## Addendum #2 Request for Bids (RFB) 2020-03 Isle of Palms Marina Rehabilitation August 28, 2020

This addendum is intended to provide further clarification to the Bid Documents for this project, dated July 10, 2020. Specifically, this addendum intends to address the bidder questions received by the City. Also, note a revised bid form is provided along with several attachments. The bid due date is also hereby extended to September 11, 2020. Bids shall be due by 11am local time on this date.

DETA DRAWING NUMBER **E8** OR USE IS PROHIBITED AND SUBJECT TO LEGAL PROSECUTION

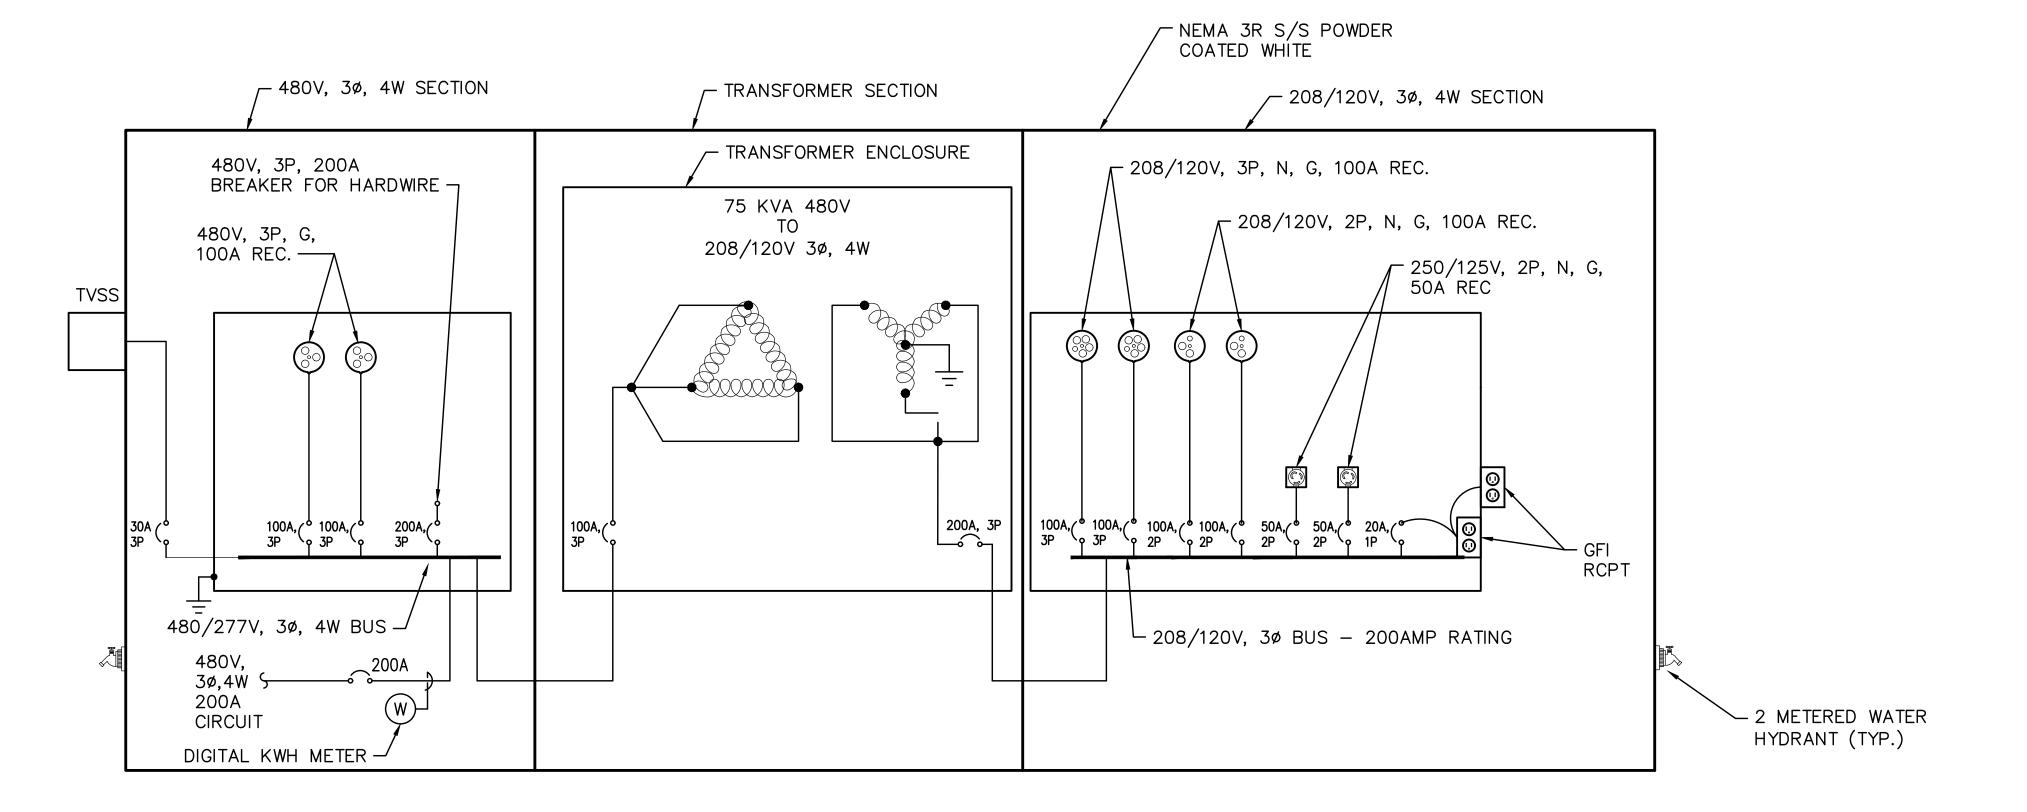
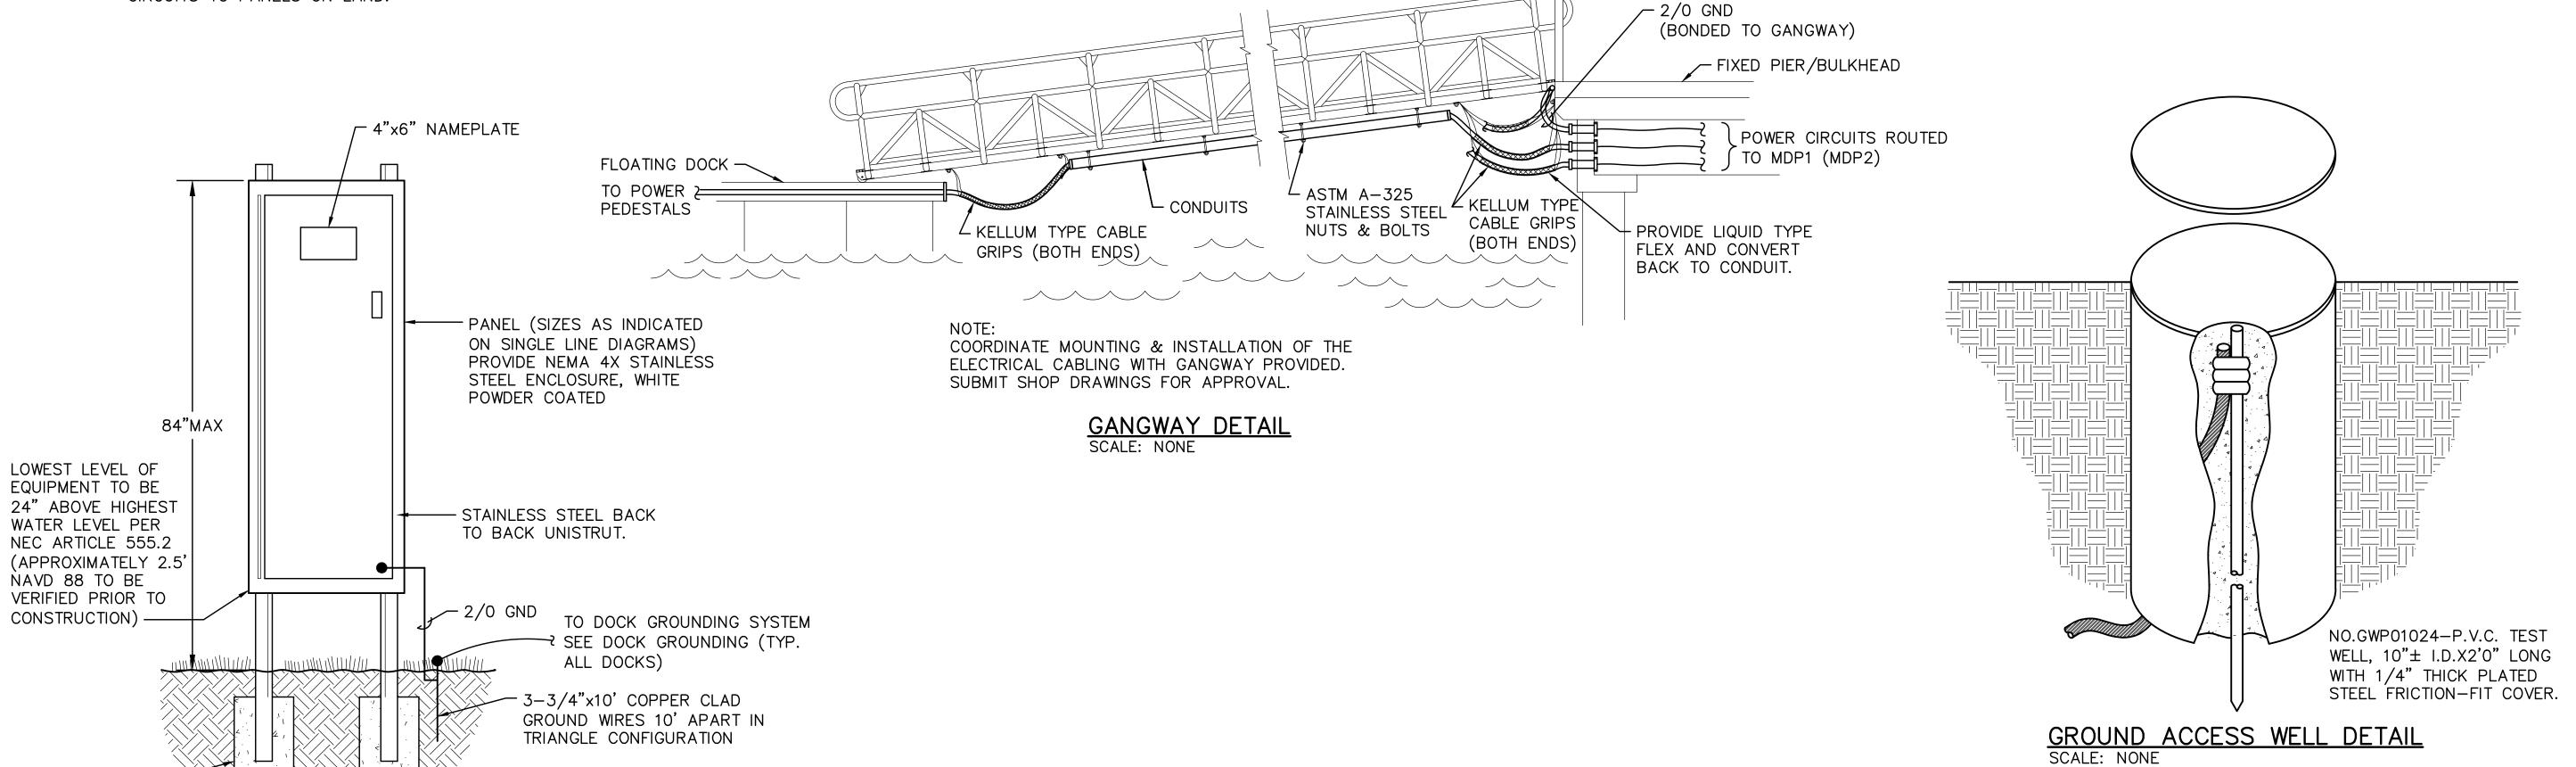
- A: Correct. No splicing.
- Q: Sheet E8, note with asterisk below cable schedule; are there "conduits" on the floating dock system, or is the note referring to the "dock utility trench system" from note 8, on E1?

- Q: Sheet E8, referring to the gangway cable installation details, is there a specific amount of cable sag required or suggested, at the bottom of the gangway to allow for tidal fluctuations?

- A: The cable from the transformer to the main distribution panels is to be type THHN/THWN in conduit. The cables from the main distribution panel to the substation and throughout the rest of the marina is to be type G-GC. Conduit is only necessary if more support than the dock system can provide is required.

FD2 FUEL DISPENSING PLAN

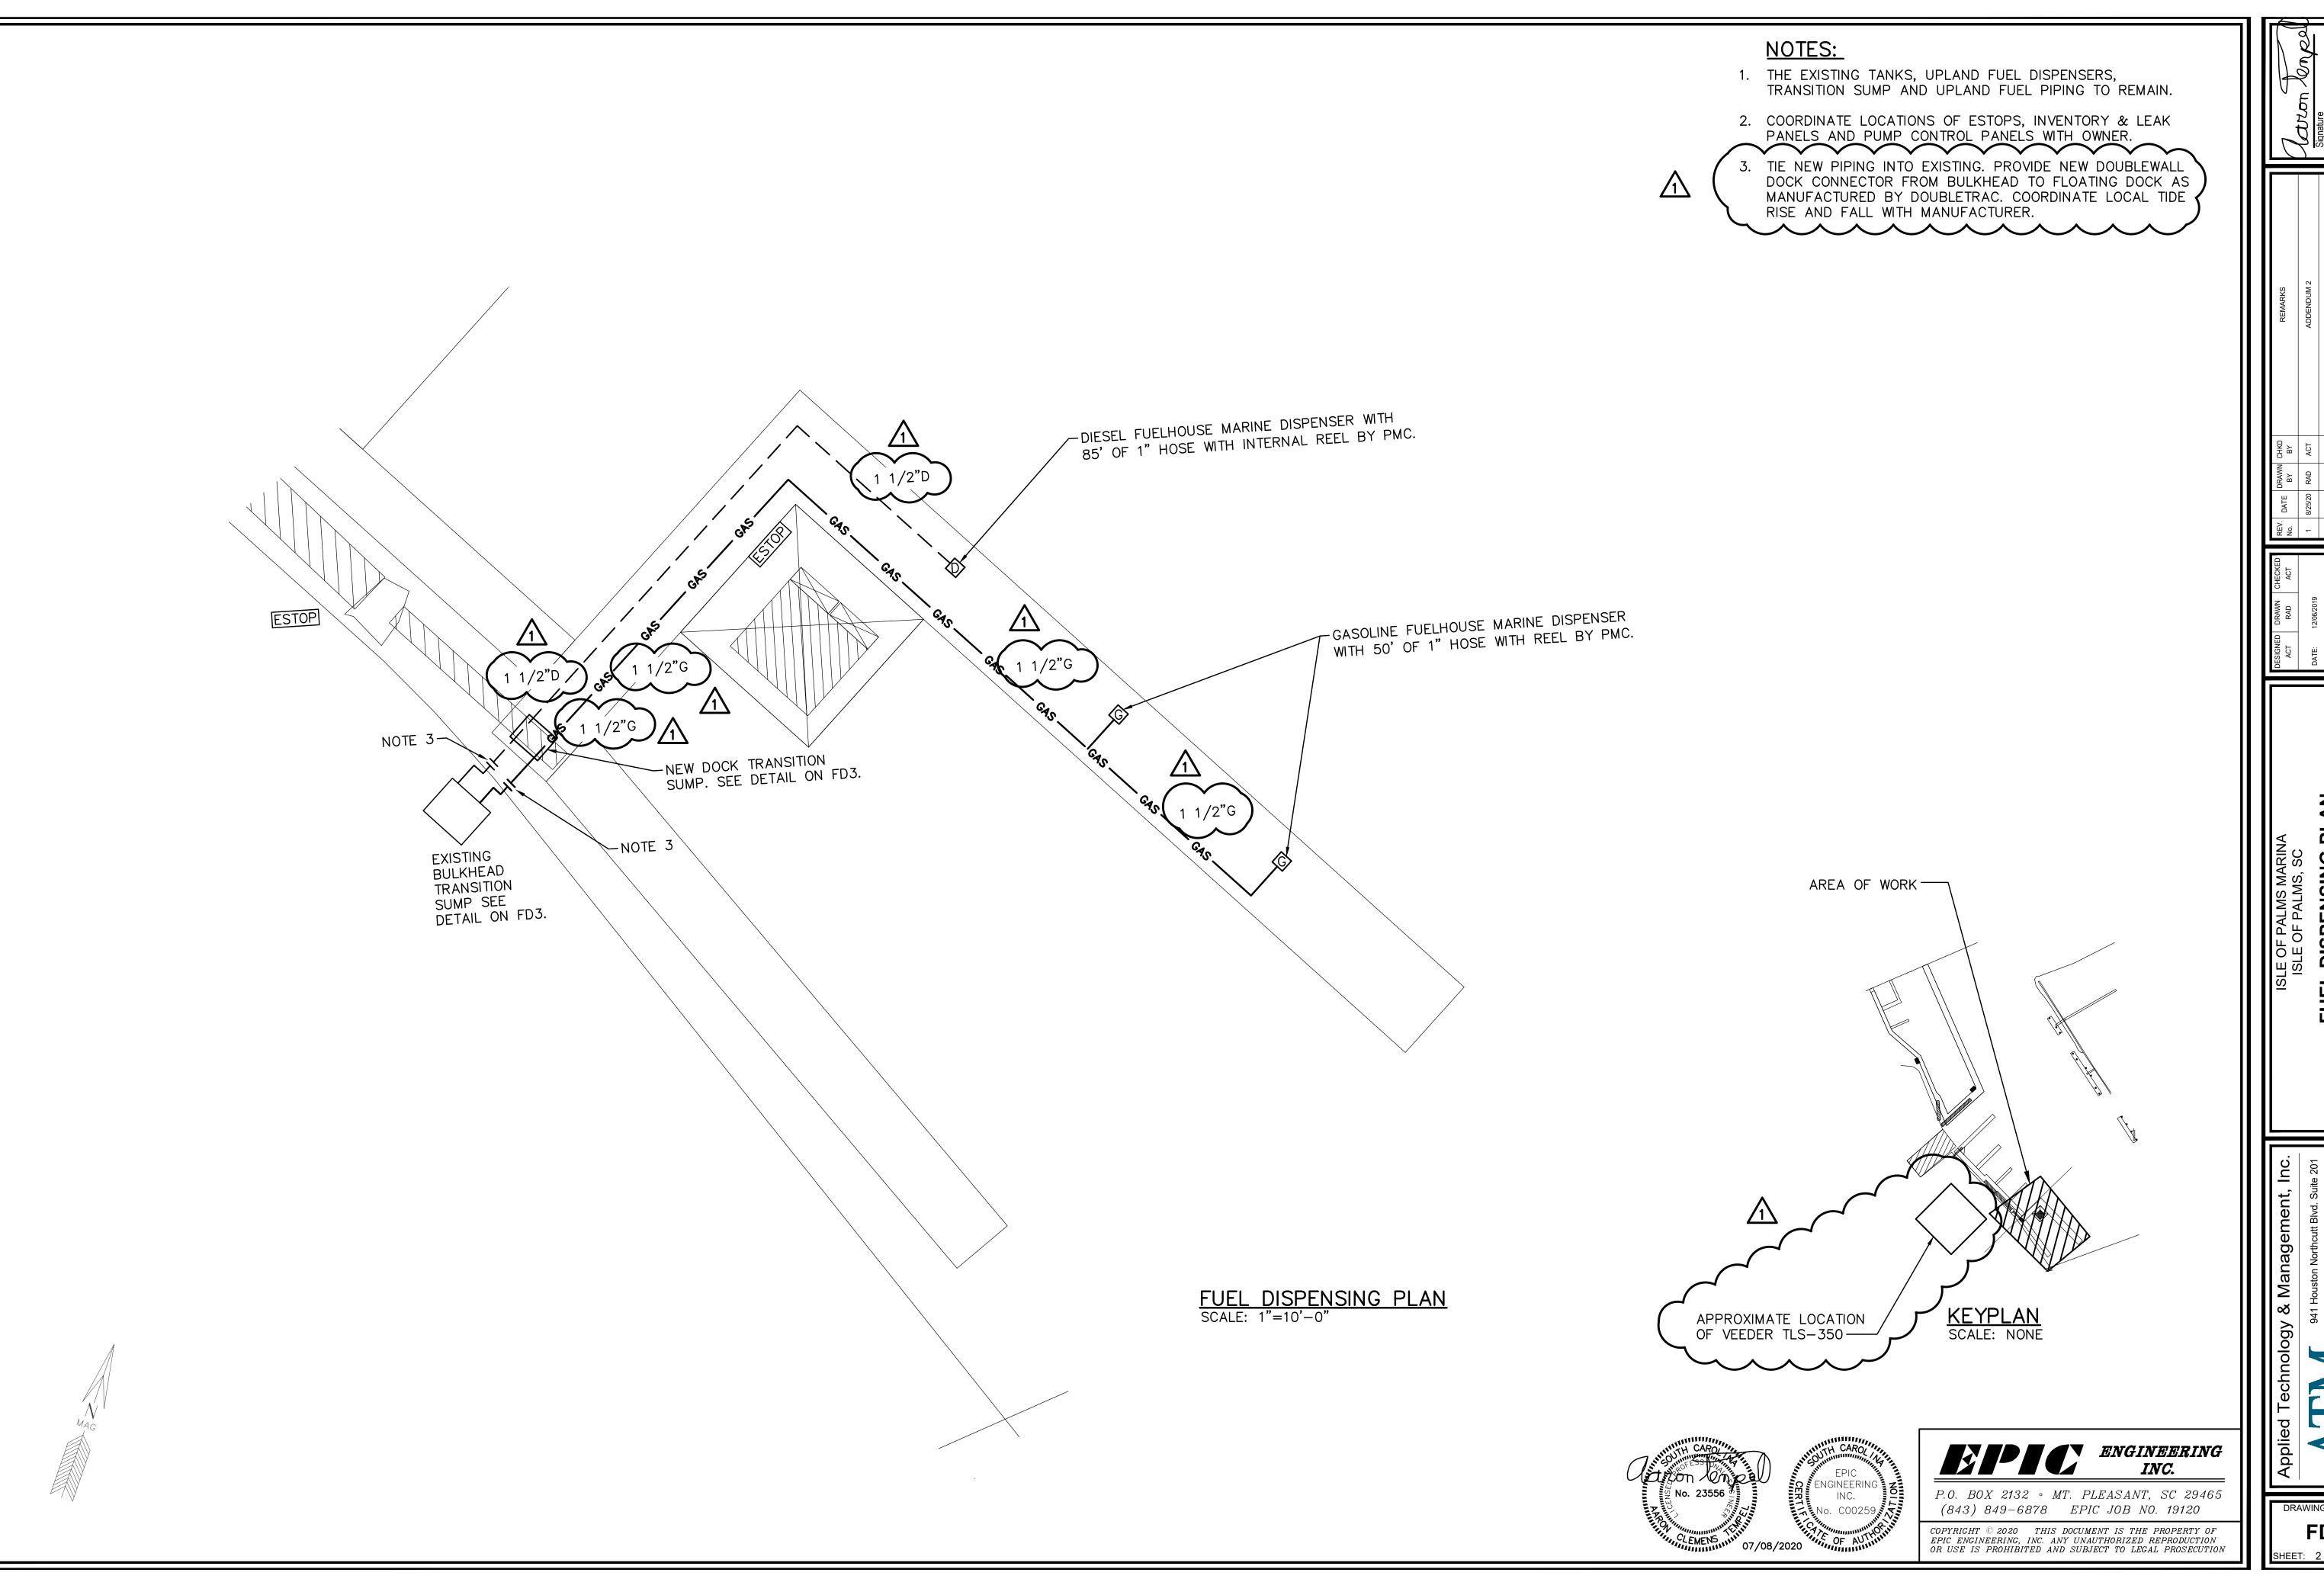
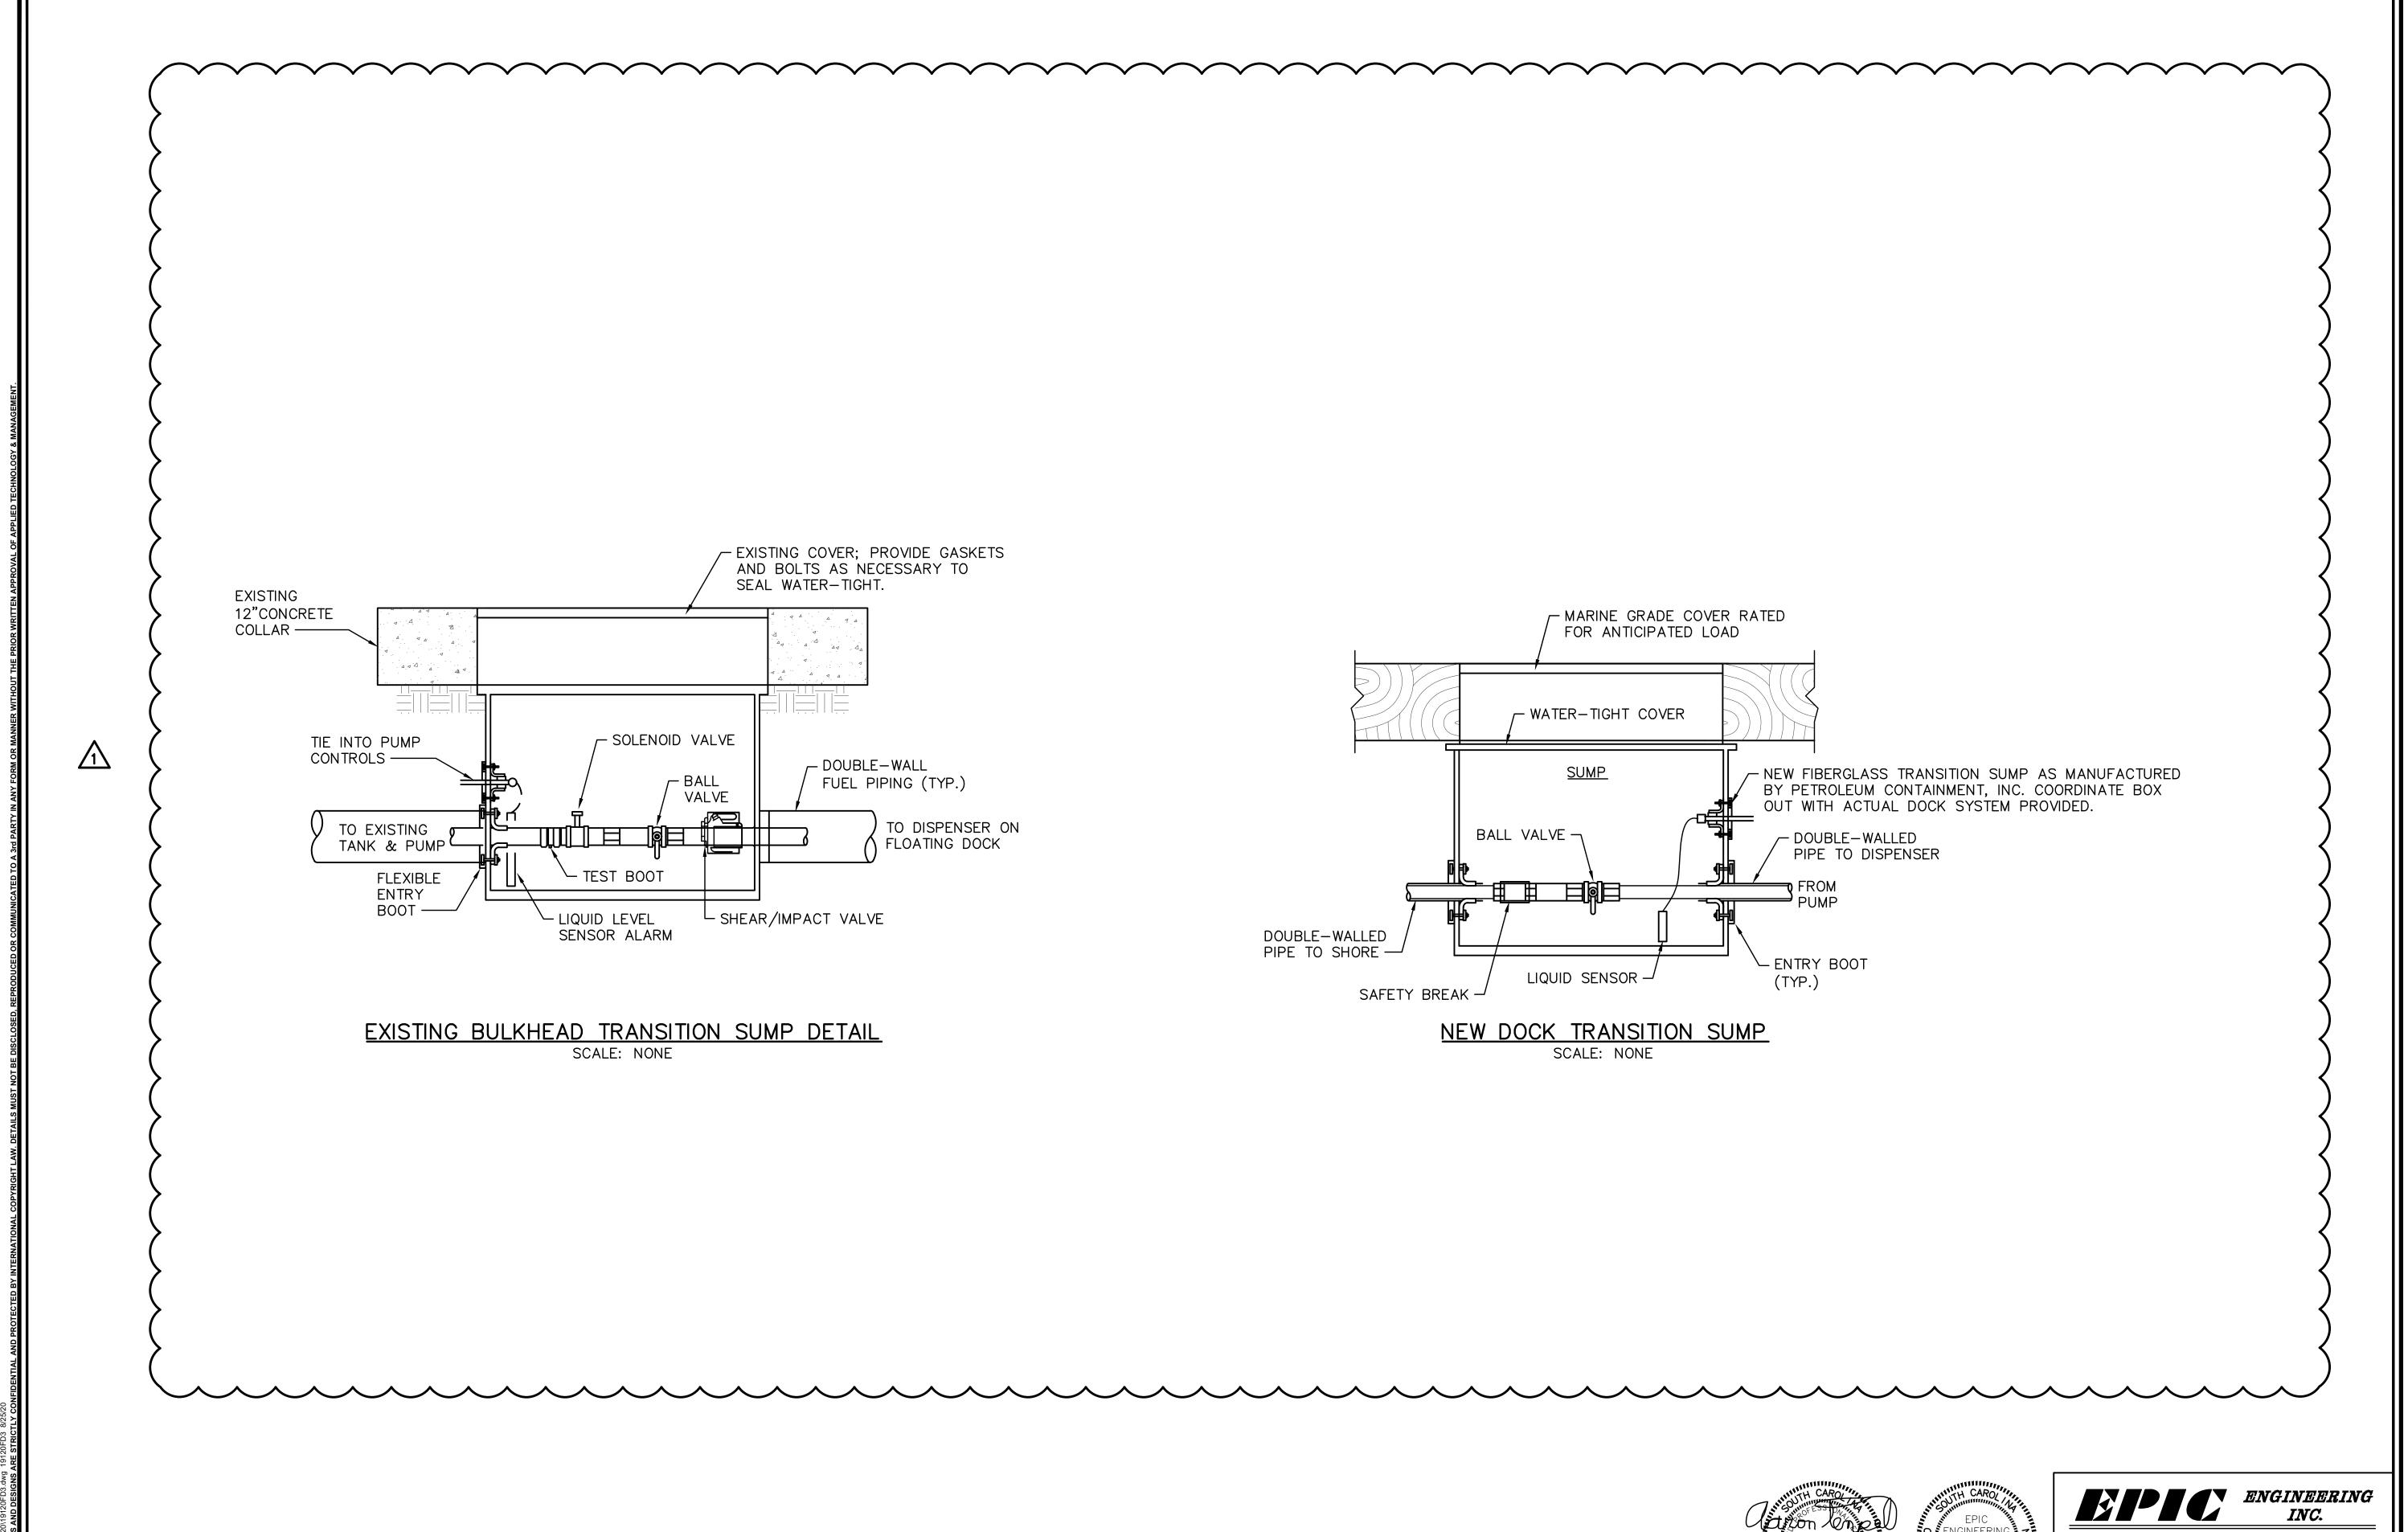
- A: Attached pleased find the original design drawings for the bulkhead as well as a recent inspection report.
- Q: Drawing FD2 shows the Omegaflex piping transition from existing bulkhead transition to new dock transition sump.

Are you requiring the Omegaflex "Double wall Dock Connector" for this specific transition?
- A: Yes.
- Q: Shown on Drawing FD2 and FD3 detail

Can the new in dock transition sump be fiberglass in place of stainless steel?

- A: Yes. Provide as manufactured by Petroleum Containment, Inc.
- Q: Omegaflex warranty installation recommends the piping be evenly supported at a minimum of 6' intervals using Omegaflex 2" vibration resistant cushion clamps/ or equal.
